3500 NE 125TH TOWNHOUSES

3023118-LU

DESIGN REVIEW RECOMMENDATION MEETING

MEETING DATE:
AUGUST 26TH, 2019

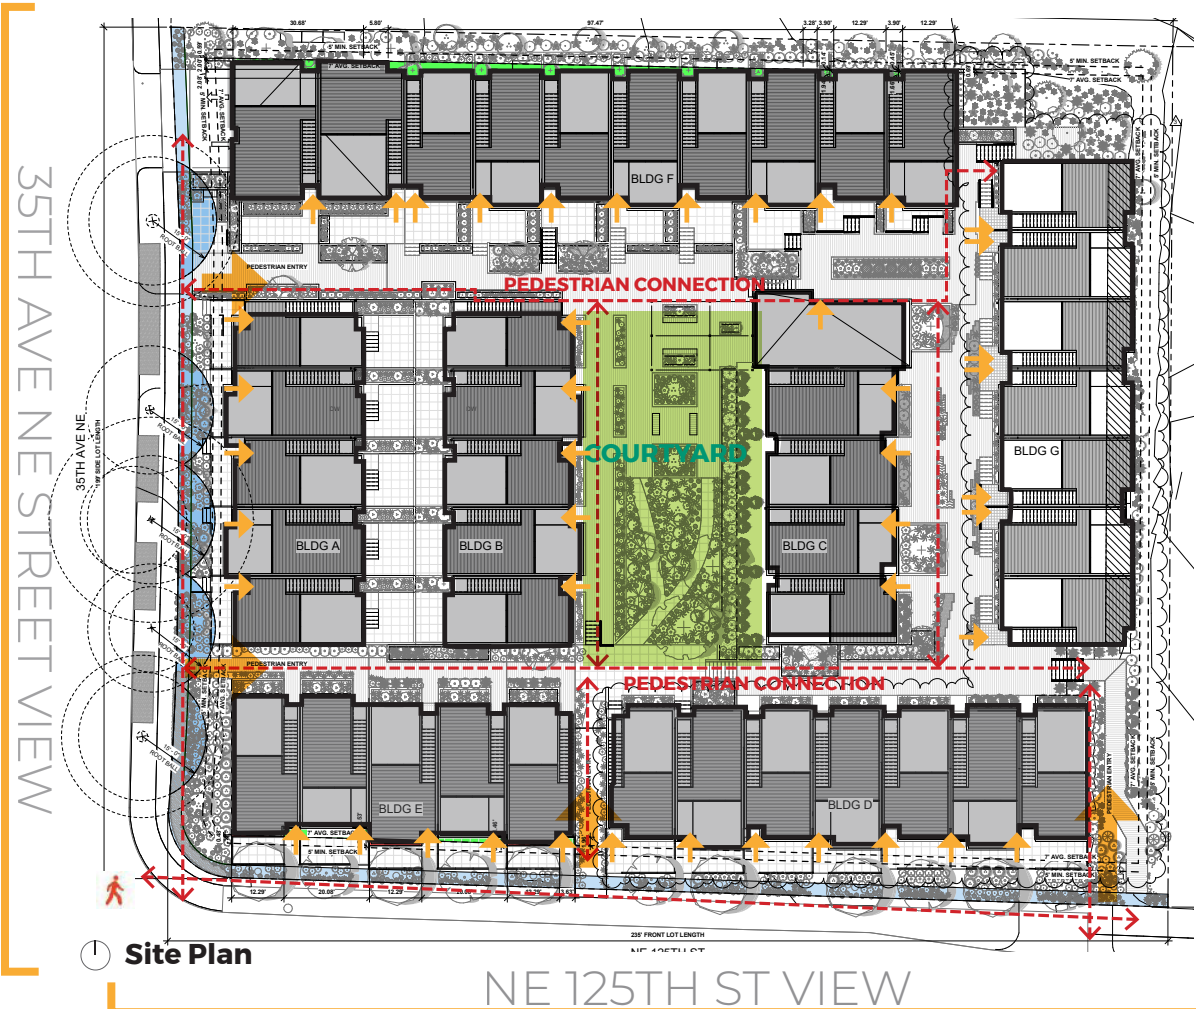
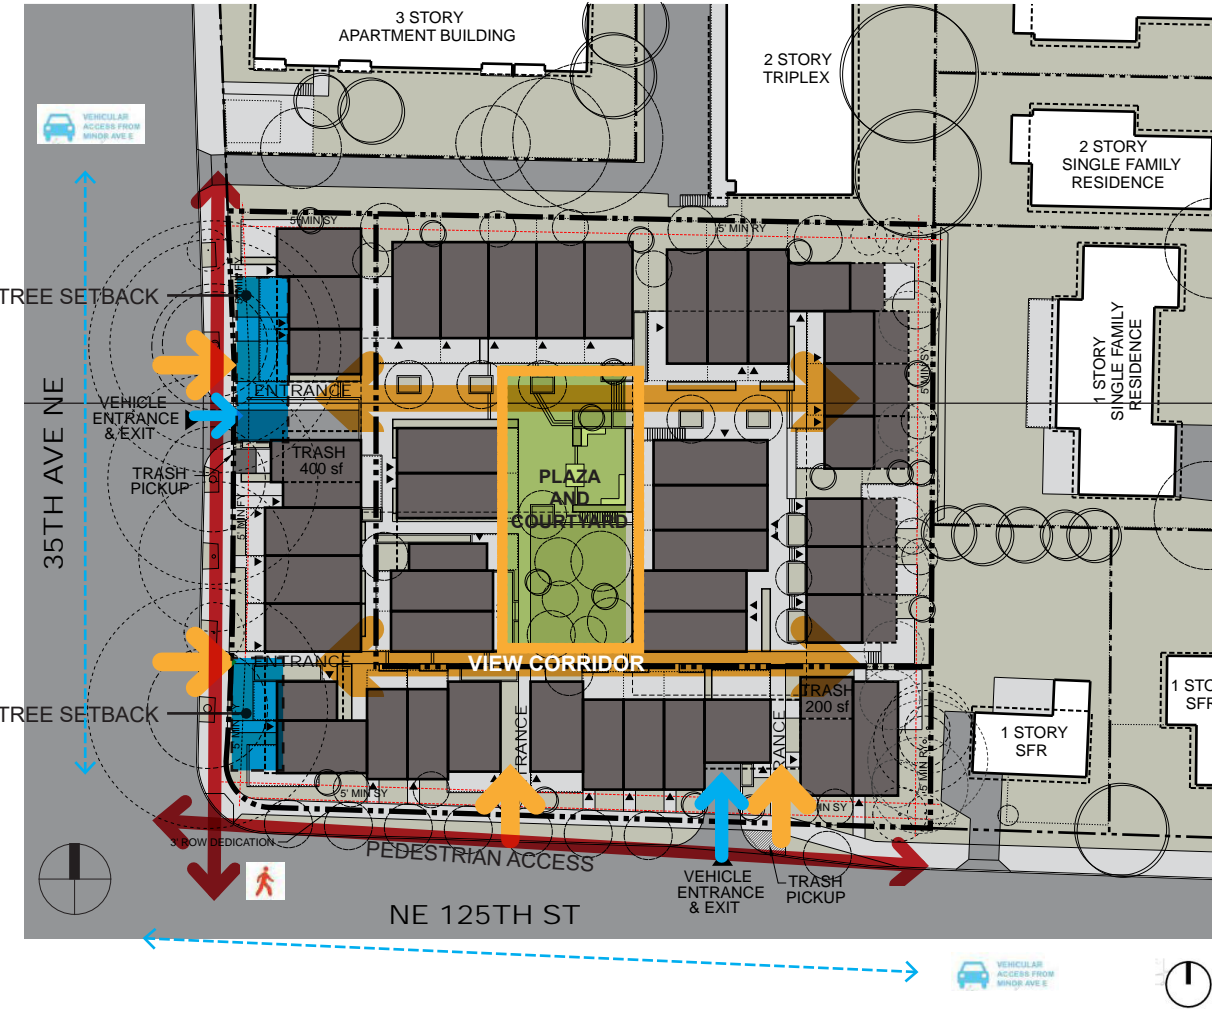
1. Pedestrian Experience:
- a. Pedestrian oriented views should be included at the Recommendation phase for perspectives at the street and amenity areas. Vignettes at the Recommendation phase showing pedestrian entrances along 35th and 125th are essential as well. (PL1-B,C, & PL3-A)

b. The Board acknowledged public comment regarding the trees and noted that the four Raywood Ash trees proposed for preservation on 35th Street are a large part of the area's identity. The modulation shown to stay out of their root zones was commended by the Board. A forthcoming arborist report for the MUP will detail preservation measures. (CS2-B)

The pedestrian experience was essential in the success of developing the design for recommendation. Specific attention was given to landscape buffers, amenity areas and courtyard space and residential unit entries. Along the street edges, the Raywood Ash trees have been preserved in the design in order to maintain the dense streetscape along 35th Ave NE, allowing the building to react and modulate as needed to stay out of root zones. Additional landscape buffers, private fenced yards, and gates help define the transition between the public zone and sidewalk area to the more private space of the residential entry stoops. Additional views and plans of each type of unit entry has been included in this packet.

Residential Entry Vignettes

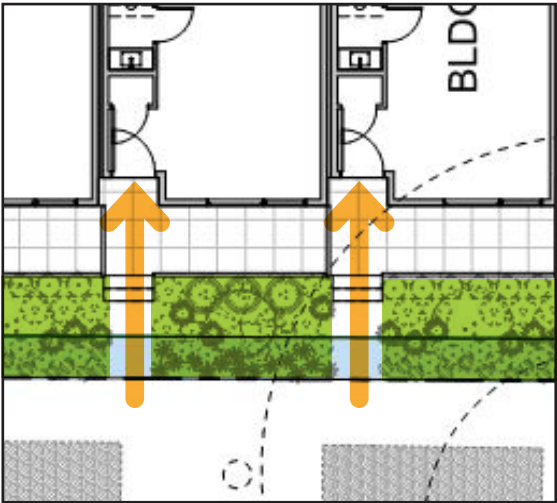
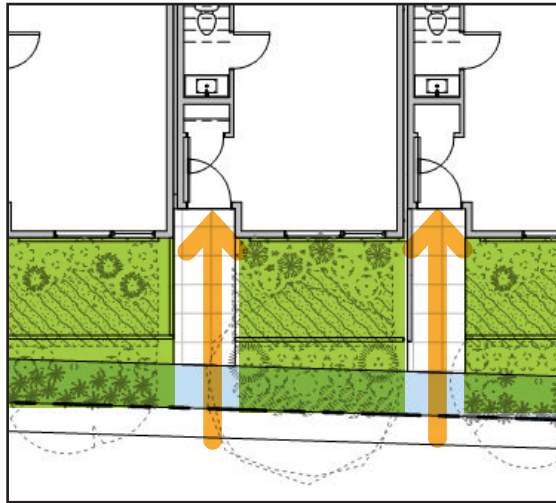
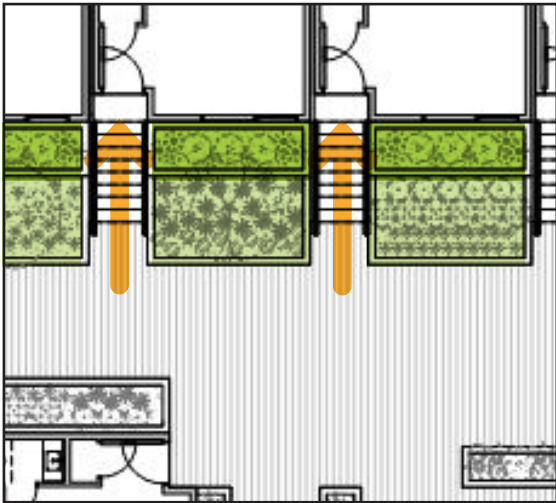
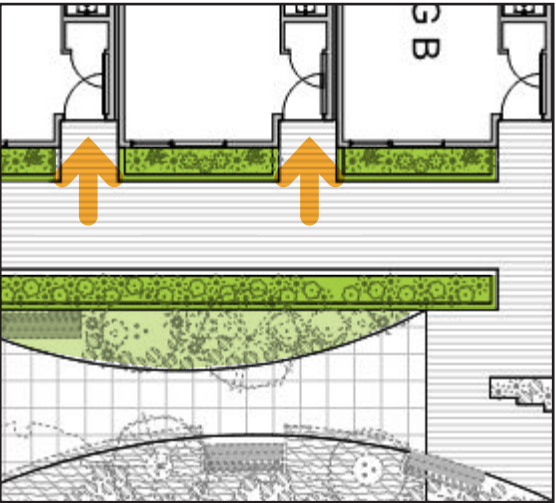
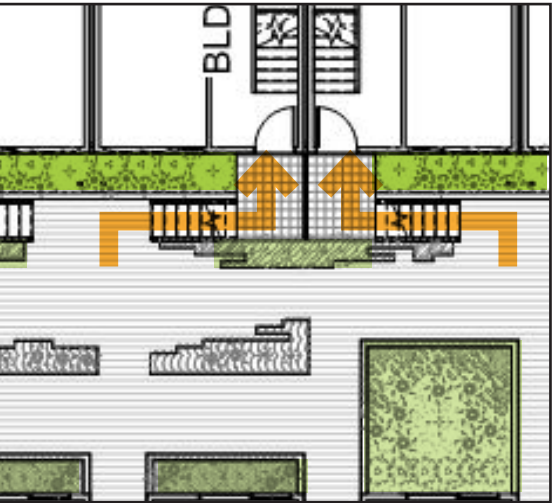
- 1. Pedestrian Experience:
 - b. The Board acknowledged public comment regarding the trees and noted that the four Raywood Ash trees proposed for preservation on 35th Street are a large part of the area's identity. The modulation shown to stay out of their root zones was commended by the Board. A forthcoming arborist report for the MUP will detail preservation measures. (CS2-B)

A formal arborist report was conducted by a certified arborist to evaluate the health and condition of all trees on and around the site. The four Raywood Ash trees will be preserved per arborists recommendations in order to provide much needed ecosystem services, shade during the summer months and light filtering during the winter. The buildings along 35th Ave NE have been setback per the required distance. Additional trees will also be planted throughout the new development, per the landscape plan.

Waste Management + Parking

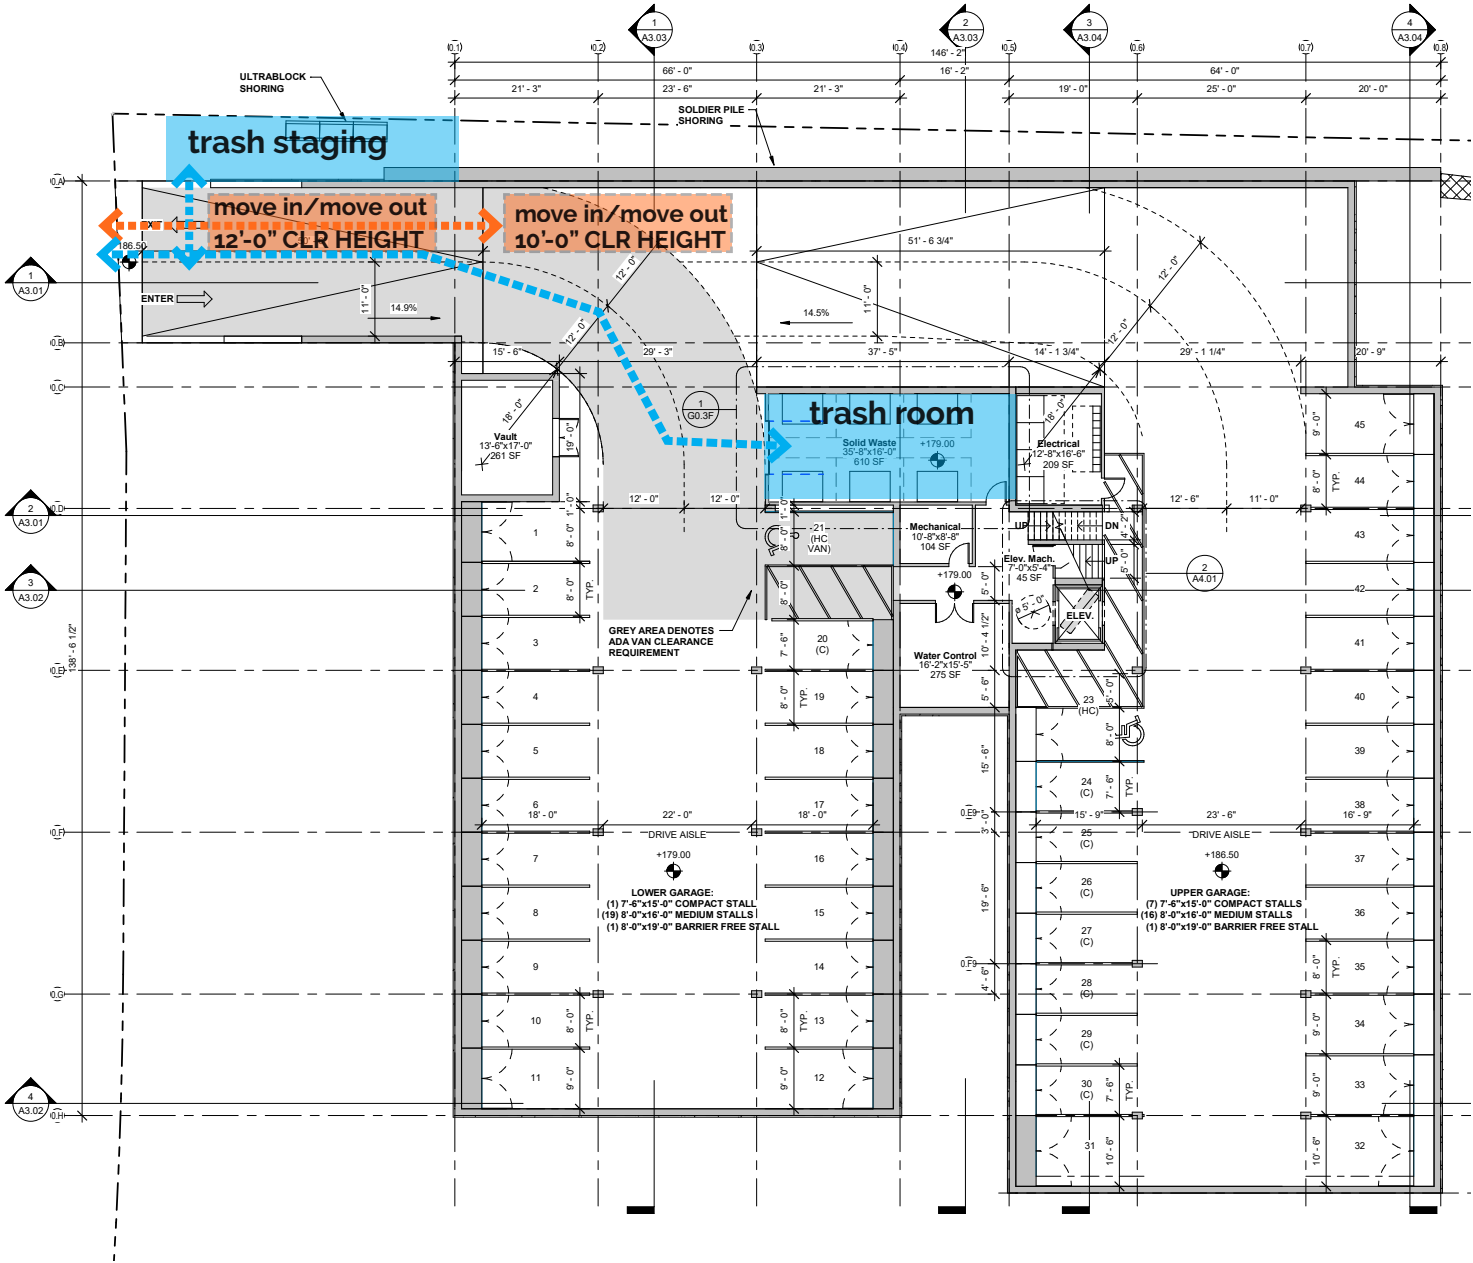
- 1. Pedestrian Experience:
c. Dumpster loading and move in/move out spaces needs to be depicted and analyzed at the Recommendation meeting. (DC1-C)

The waste storage and trash room is located in the basement, garage level for ease of access. The trash will be staged along the north property line and screened using a 4'-0" tall cedar fence. The natural topography also helps to minimize the impact of the staging area.

Move in and move out, while not happening often, can be accomodated by using the garage level. Moving vans up to 10'-0" in height can be accomodated in the lower part of the garage and parking space for trucks up to 12'-0" can be accomodated on the ramp for conveience.

35th Ave NE Development

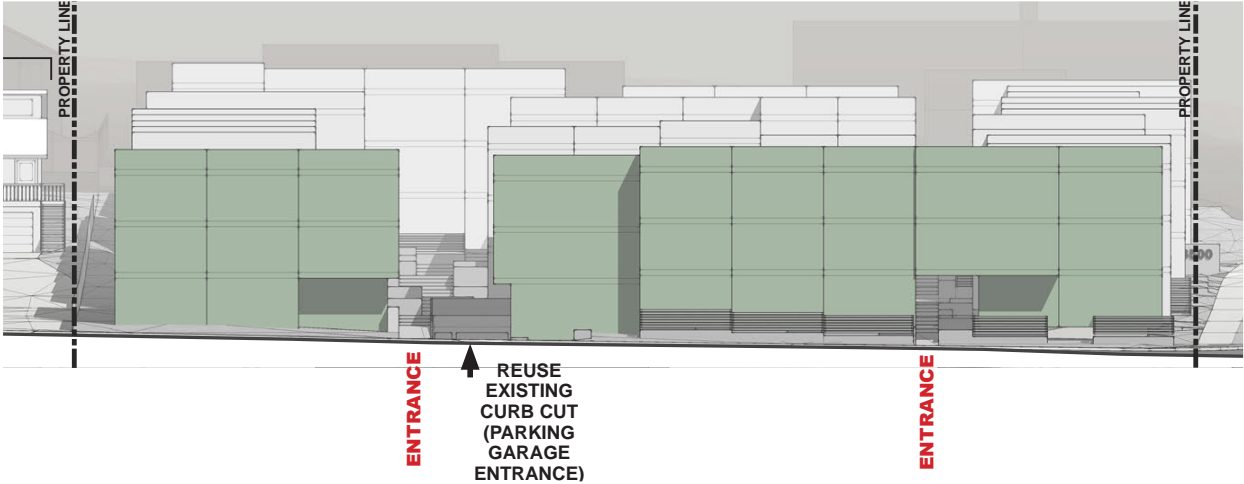
- a. The Board agreed with public comment and favored the third option for the underground parking, the large central amenity space, and the amount of modulation present. (DC2-B and DC3-A&B)
- b. Groups of townhomes should have unique character broken up into groups of two or three. (DC2-B Scale)

- b. The townhouses were then broken down into groups of two or three, each having a unique character and sense of identity through differentiating the fenestration and material patterns. You can see below these material changes and facade modulation, further emphasized through a bold blue color, in the gasket of the townhouses.

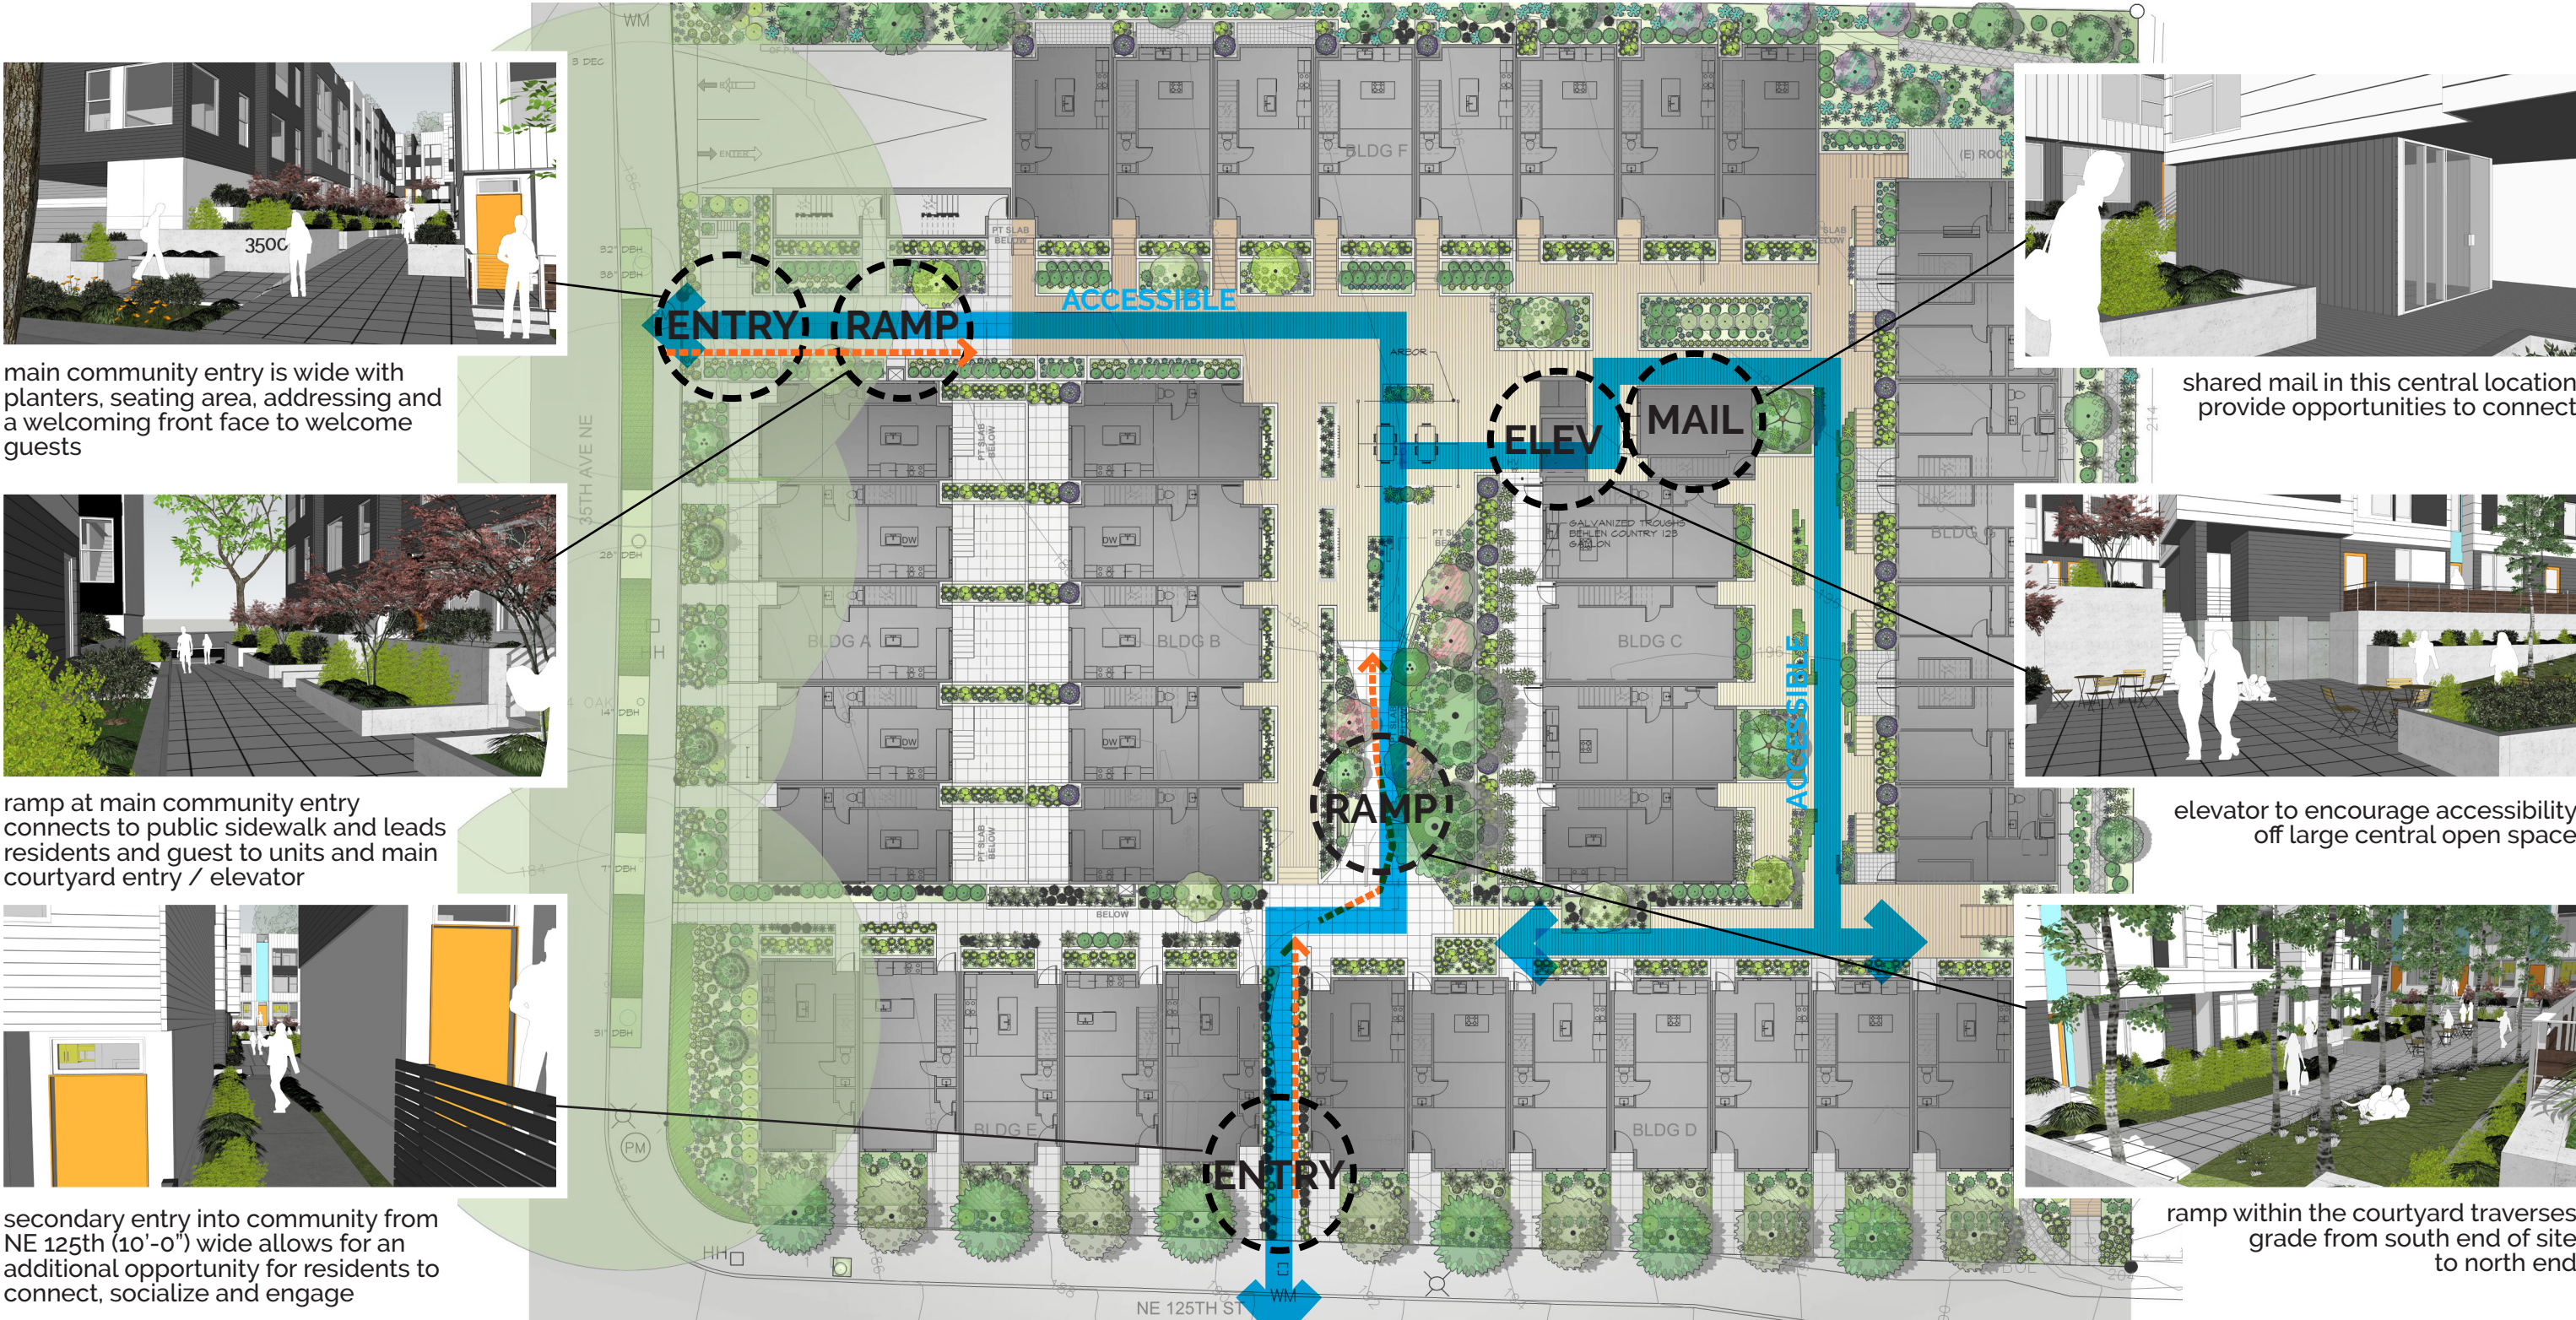
- a. There should be an elevator from the garage or a well-designed ramp for accessibility. Both should be integrated into the open space and not hidden. (CS1-C)
- b. Board stressed that consideration of the walkways and amenity space for universal accessibility i.e. wheelchairs, strollers, bikes is critical. Since there is substantial grade change from the sidewalk, individual unit access from the amenity area should be considered. (DC3-C, PL1-A, PL2-A)
- c. Explore opportunities to create a sense of community through shared space such as location of the mail

Creating opportunities for community, shared connection and universal accessibility was one of the principal drivers in developing option 3 from EDG. The design has maintained the large central open space in the center of the project and has further developed opportunities for residents to connect by adding an elevator in the mail room that also doubles to provide intergrated, universal accessibility.
